Comments of the ISO/RTOs
NAESB Coordinate Interchange Business Practice Standard
(Request For Interchange, RFI)

The ISO/RTO Council (IRC) appreciates the opportunity to make comments on the NAESB proposal for Coordinate Interchange Business Practices. We believe that NAESB's attempt to move the industry toward the Functional Model is a good first step toward the future. In general, we support this document as a way to move the current NERC processes into the realm of NAESB. We believe that NAESB should look for opportunities to improve the process along the way, recognizing that NERC is moving rapidly to implement its Functional Model.

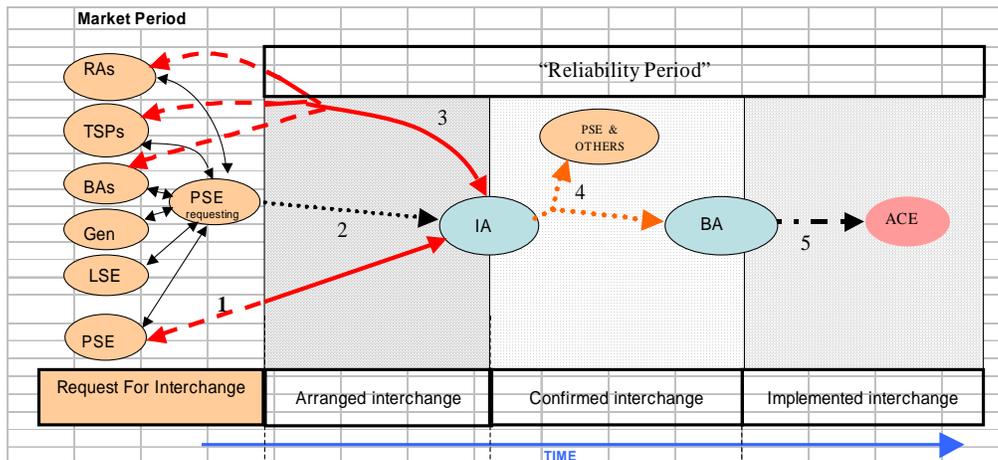
The information submitted to the IA needs to be determined by the minimum data set that the BA’s need to implement the transaction in their ACE. This is not market sensitive information. Since the IA is obligated to supply only the necessary information a BA needs to take the transactions physical, the information should be determined under the NERC standard for IA to BA communication during the Confirmed Interchange Period. See diagram below.

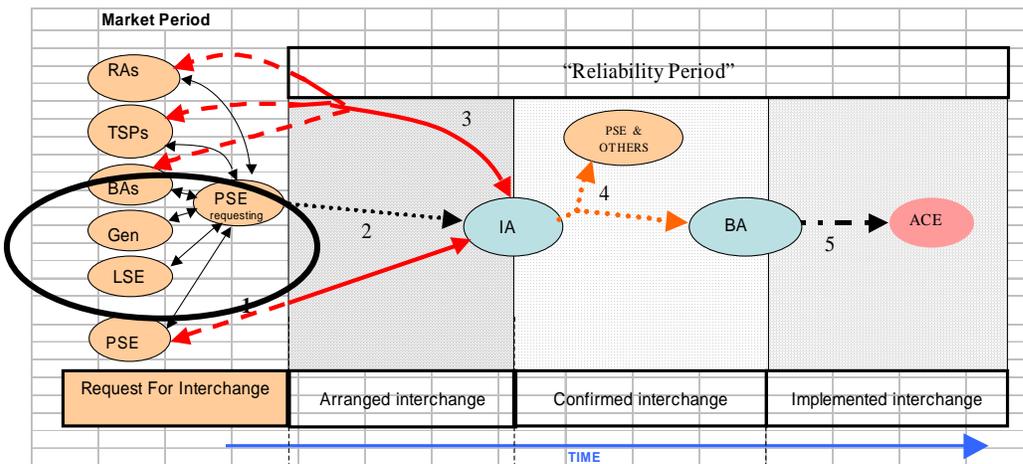
The words “verify approvals” should be changed to “confirm approvals”. Since the PSE is required to submit a balanced schedule to the IA, the PSE has already obtained a set of preliminary approvals from all parties to the transaction. The IA function is simply to confirm all “reliability” parties (RA, TSP & BA) have in fact agreed to schedule the energy as specified and once confirmed, pass the schedule to the BA for implementation.

Also per the diagram there is no obligation for the IA to communicate with the Generator/Load PSE. Is there a necessity for this layer of communication to occur? See diagram below. There is no need for the IA to contact the Generators or LSEs.
